PLANNING COMMISSION AGENDA

6. QuikTrip CUP and Commercial Site Plan Approval at approximately 7716 S 2700 East, Applicant: Galloway and Company, QuikTrip Corporation

RE: **QUIKTRIP 7489 - CUP & PRELIMINARY SITE PLAN REVIEW**

Re: **Comment Response to “QuikTrip 7489”**

- QT Logo
- Silver Fabricated Aluminum Divider
- Two (2) Product LED Gas Price Sign
- 386.9 Square Feet Sign Area

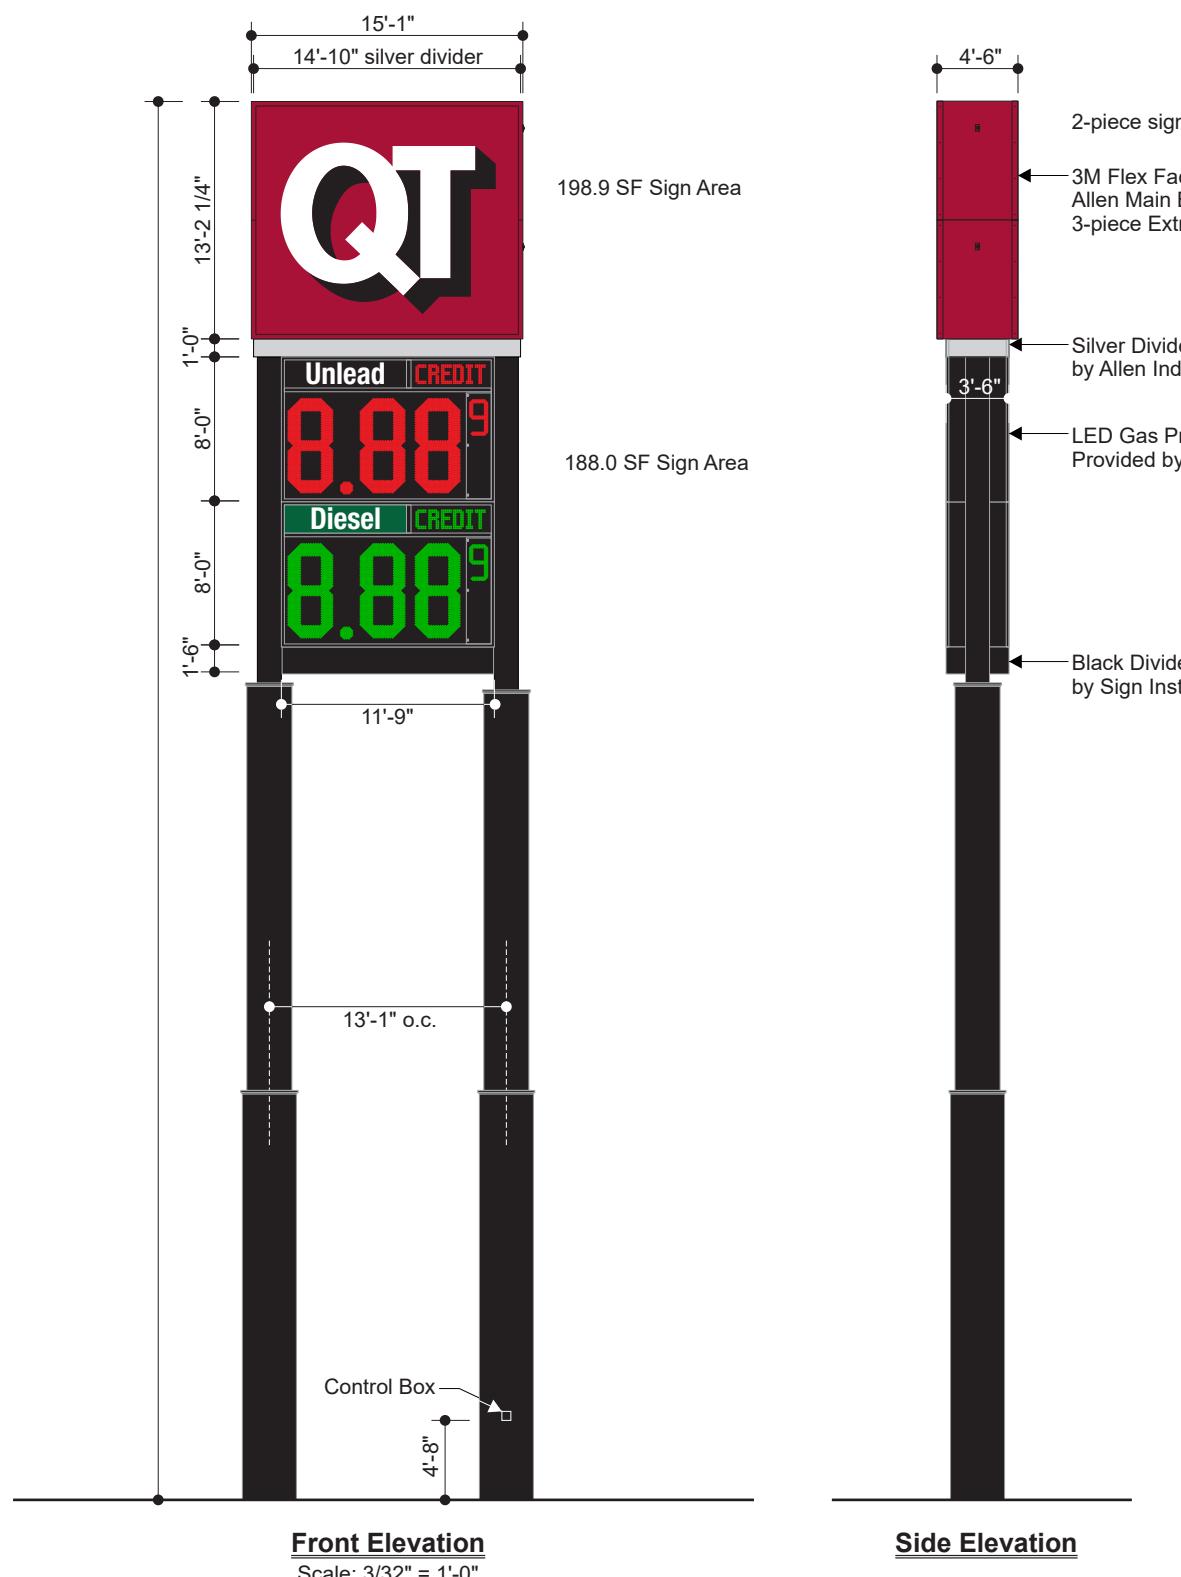
A. Class 5 signs are allowed on the site.
 B. A Building Permit for the proposed signs is required prior to construction.
 C. The maximum size allowed for the Highway 89 oriented pole sign is 450 sf. The proposed pole sign is 684.3 sf. This sign will need to be revised to meet the size requirements.
 D. The maximum size allowed for the ground sign is 272 sf. The proposed ground signs are 66.9 sf. This is acceptable.
 E. The maximum height allowed for the Highway 89 oriented sign is 100 ft. The proposed sign height is 100 ft. This is acceptable.

Response: An alternative sign design complying with City sign size requirements has been included with this submittal. An exhibit showing alternative locations for the high rise sign has been included as Exhibit 1: Signage Exhibit. Final sign permitting will be addressed through the Building Permit process.

LANDSCAPE PLAN RENDERING

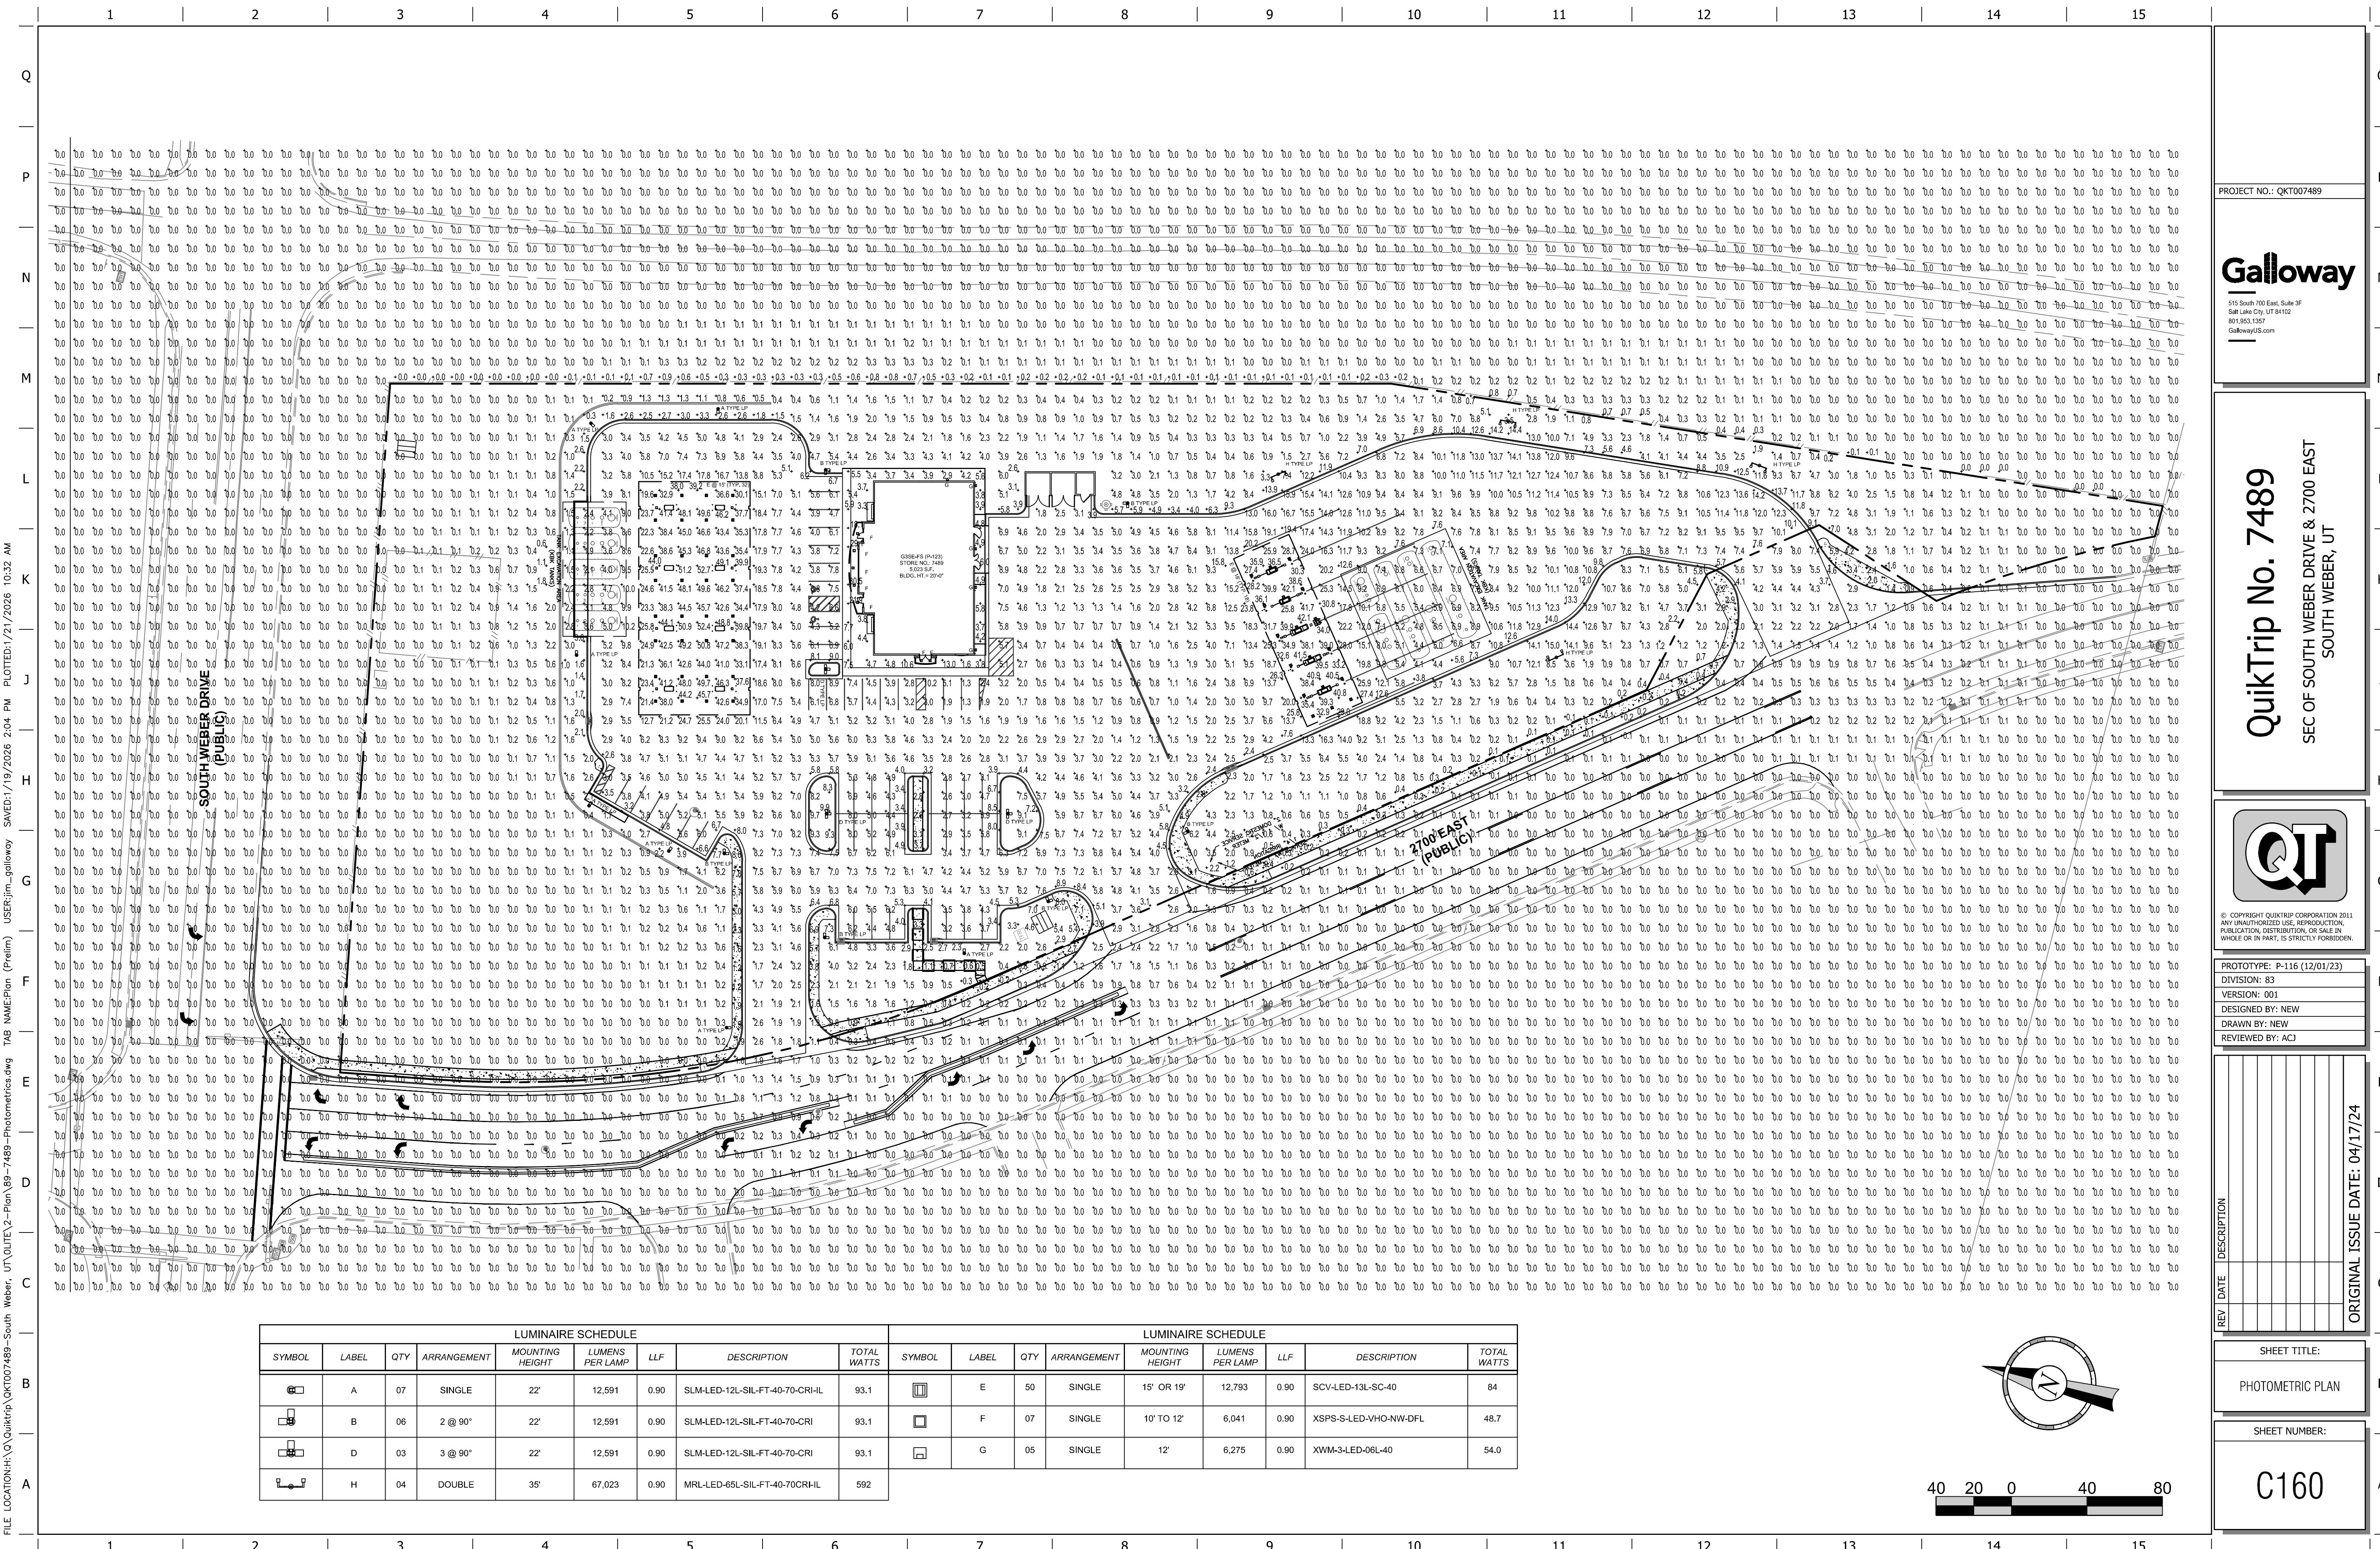
F. *An Irrigation Plan must be submitted. Please show the location of the required backflow prevention assembly (see City Standards, Sheet CW7) and how it will connect to the culinary water supply and sprinkler system.*

Response: Native seed replaced with rock mulch.

Response: Revised plans to remove buffer yard trees. A 6' fence has been added along the Highway property line. A wooden fence is recommended, as this is QuikTrip's standard and aligns with what they are familiar with maintaining and repairing.
